**PLANNED UNIT DEVELOPMENT
& SUBDIVISION STAFF REPORT****Date: December 21, 2006**

DEVELOPMENT NAME Carpenter's Place Subdivision, Resubdivision of Lot 2

CONTEMPLATED USE Planned Unit Development Approval to allow reduced lot widths, and sizes, and reduced building setbacks in a single-family residential subdivision, and Subdivision approval to create five lots from one lot.

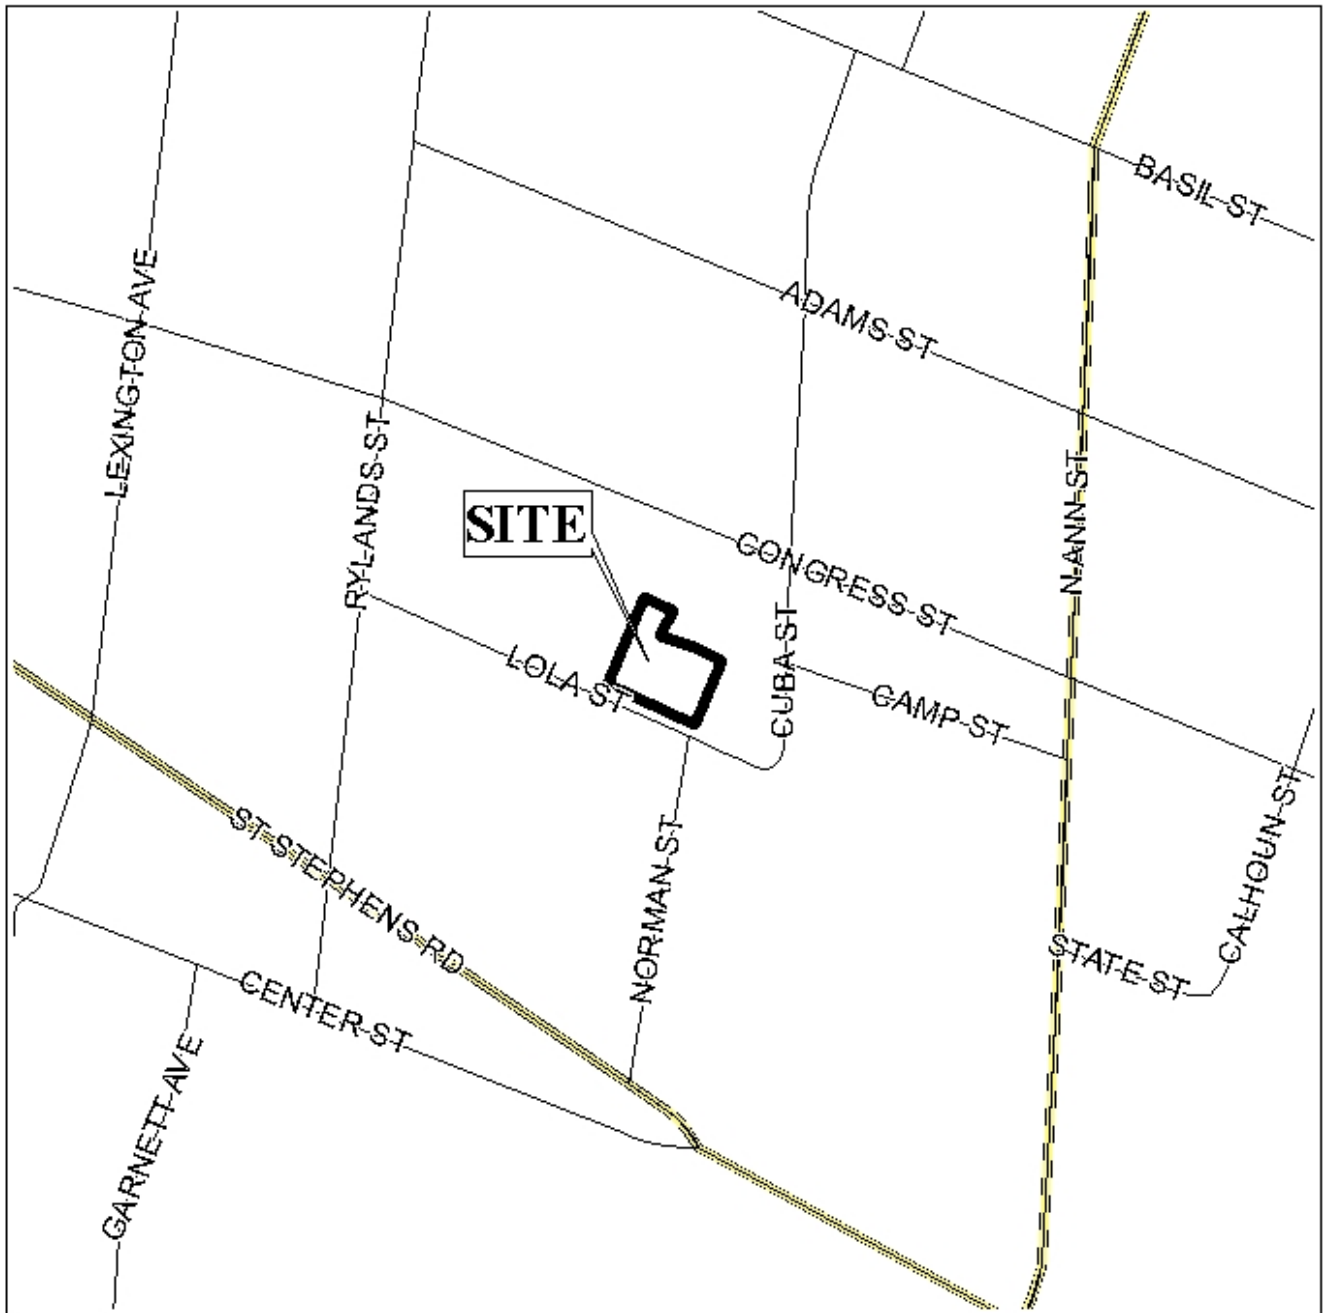
The applicant proposes to create four lots to accommodate the existing “shotgun” homes, and a new lot. The existing homes are approximately 810 square feet each (including porch), and would be on lots ranging from 1,941 to 2,749 square feet – resulting in site coverages ranging from 29.5% to nearly 42%. The minimum existing side yard setback appears to be 2 feet 6 inches, and the existing front yard setback appears to be approximately 6 feet. All rear yard setbacks appear to comply with the minimum requirements of the Zoning Ordinance. The four lots that will encompass the existing homes range from 20.82 feet to 21.37 feet in width. The fifth lot would be approximately 40.88 feet wide and have an average depth of 96 feet.

Typically, the front yard setbacks required by the Subdivision Regulations, and in R-1 zoning districts for lots, are 25-feet for new construction, however this site is located in the Campground Historic District, a National Register listed historic district (but not under the purview of the local Architectural Review Board). Because of the historic nature of the area, a reduction in the front yard setback would be appropriate, and it is recommended that a minimum front yard setback of 10 feet be allowed (as the district is not locally recognized, the Historic District Overlay does not apply). Furthermore, the minimum lot sizes and dimensions of both the Subdivision Regulations and the Zoning Ordinance should be waived to accommodate the preservation of the existing historic structures.

Planned Unit Development: The application is recommended for Approval, subject to the following conditions: 1) placement of a note on the site plan stating that Lots 1, 2 and 5 are limited to 35% site coverage, and that Lot 3 is limited to 41% and Lot 4 is limited to 42% site coverage; 2) depiction and labeling on the site plan and plat of a 10-foot minimum building front yard setback line for all lots; 3) depiction and labeling on the site plan of the side yard setbacks for Lots 1-4, to be based on the existing setbacks; 4) placement of a note on the site plan stating that standard side yard setbacks, adjusted for the lot width, shall apply to Lot 5; 5) depiction and labeling on the site plan of the standard 8-foot rear yard setback for all lots; 6) placement of a note on the site plan and plat stating that the shotgun structures located on Lots 1-4 are contributing structures to the Campground Historic District, as listed on the National Register of Historic Places; 7) placement of a note on the site plan and plat stating that each lot is limited to a maximum of one curb-cut, with the size, design and location to be approved by Traffic Engineering, and conform, where possible, with AASHTO standards; and 8) provision of a revised PUD site plan to the Planning Section of Urban Development prior to the signing and recording of the final plat.

Subdivision: With a waiver of Sections V.D.2. and V.D.9., this application is recommended for Tentative Approval, subject to the following conditions: 1) placement of a note on the plat stating that site coverage, side yard and rear yard setbacks are as depicted on the revised PUD site plan; 2) depiction and labeling on the plat of a 10-foot minimum building front yard setback line for all lots; 3) placement of a note on the plat stating that each lot is limited to a maximum of one curb-cut, with the size, design and location to be approved by Traffic Engineering, and conform, where possible, with AASHTO standards; and 4) placement of a note on the plat stating that the shotgun structures located on Lots 1-4 are contributing structures to the Campground Historic District, as listed on the National Register of Historic Places.
